STAFF REPORT
COMMUNITY DEVELOPMENT DEPARTMENT

HEARING DATE: 2/22/2022

SUBJECT: FP-2022-0001
Oakwind Estates No. 1

Final plat consisting of 91 townhouse lots, 24 single family detached lots, 2 common driveways and 16 common lots on 16.83 acres of land in the R-15 zoning district.

B. Final Plat (date: 1/6/2022)

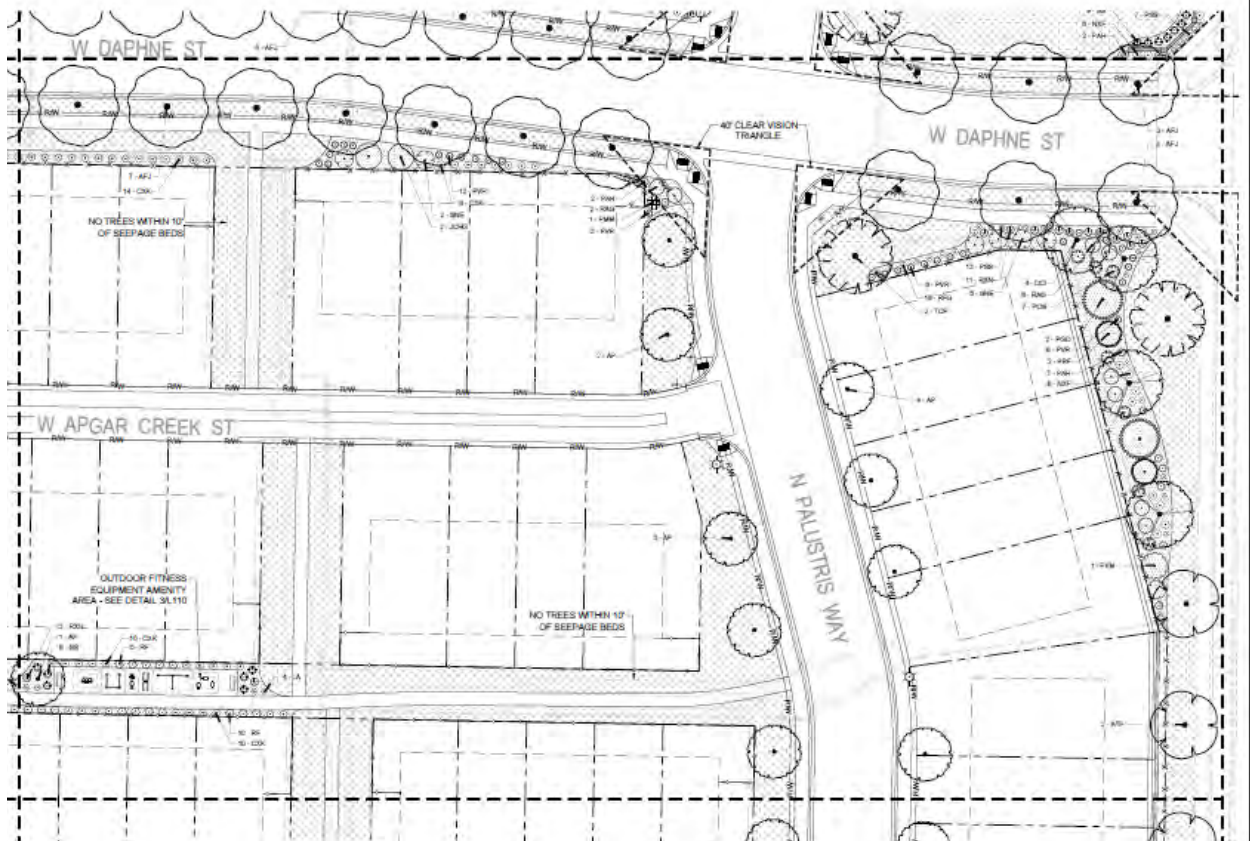
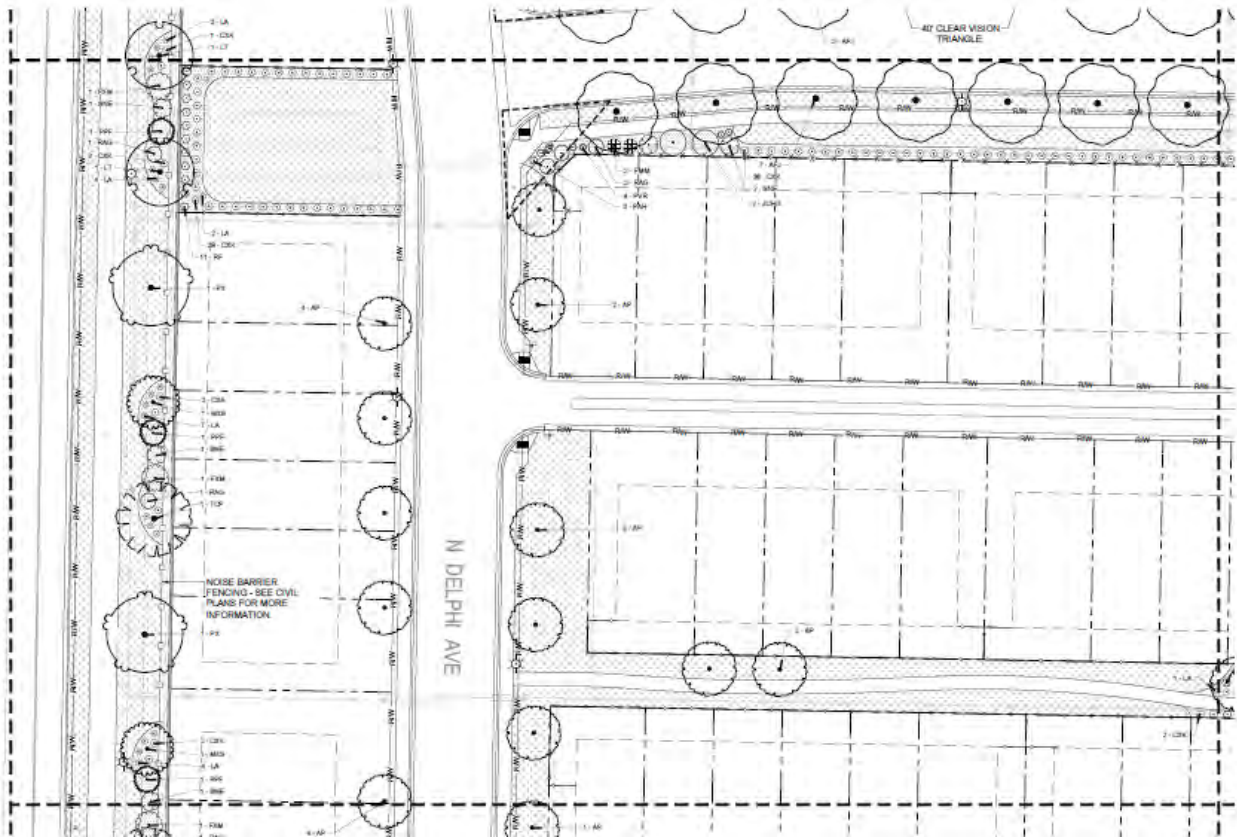
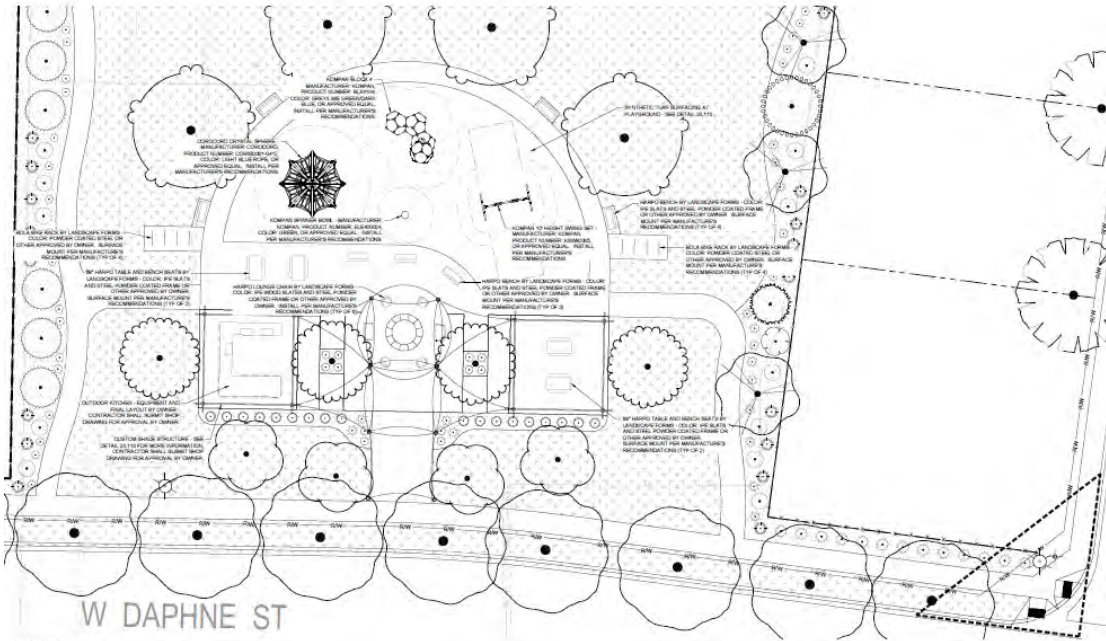
5. Prior to City Engineer signature on the final plat, the final plat prepared by Land Solutions, stamped by Clinton W. Hansen, dated: 01/06/2022, included in Section V.B shall be revised as follows:

- a. Note 10, add Instrument Number.
 - b. Note 12, add Instrument Number.
6. The landscape plan, prepared by Stack Rock Group on January 7, 2022 is approved with the following revisions:

D. Proposed sound wall example.

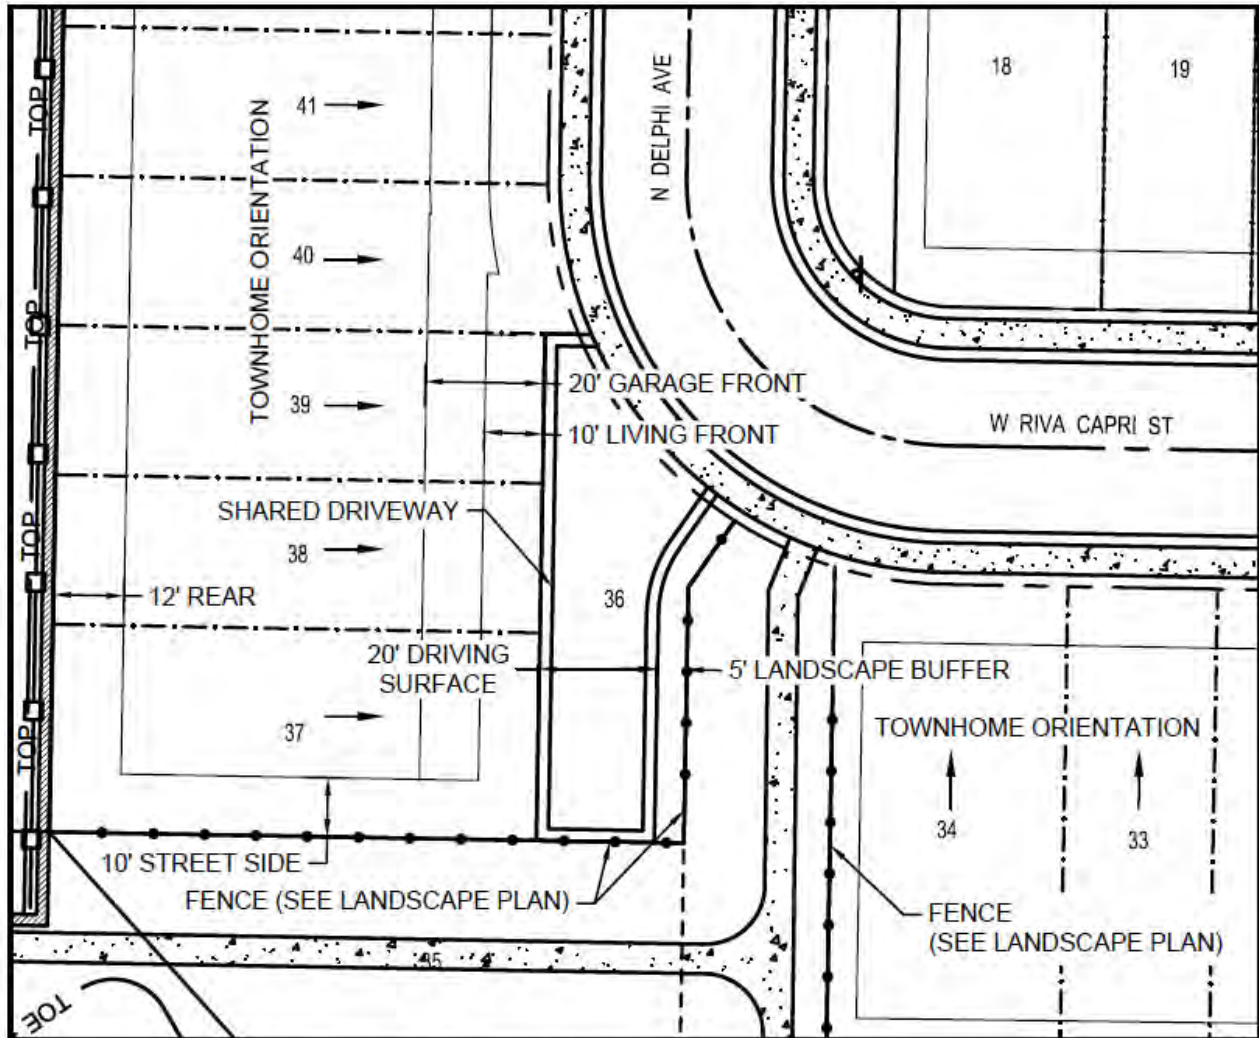
The applicant has responded that there would be an additional environmental quality improvement for granting the request. The wall as proposed is a steel type of fencing that will be more aesthetically appealing as it is designed to look more like a fence than a traditional concrete or modular block wall, however it is not engineered for staggering. The applicant notes this same style of wall was utilized by the Oaks North and South Subdivisions.

The Director agrees that the style of wall proposed is more attractive than a concrete or block wall as it resembles a fence. Also, this sound wall is proposed in combination with a 4 ft. tall landscaped berm, which would provide additional visual relief. The Director finds the alternative compliance provides an equal or superior means for meeting the requirements and will not be materially detrimental to the public welfare or impair the intended uses and character of surrounding properties.

However, it is not clear on the landscape plan that berming is included. Staff recommends a condition that this be clarified on the landscape plan prior to City Engineer signature of the final plat.

- a. It should be clarified on the landscape plan that there is a 4 ft. high berm in addition to the noise wall along N. McDermott Rd.
 - b. All pathway lots shall be planted in accordance with UDC 11-3B-12 including a landscape strip a minimum of five (5) feet wide along each side of the pathway and shall.
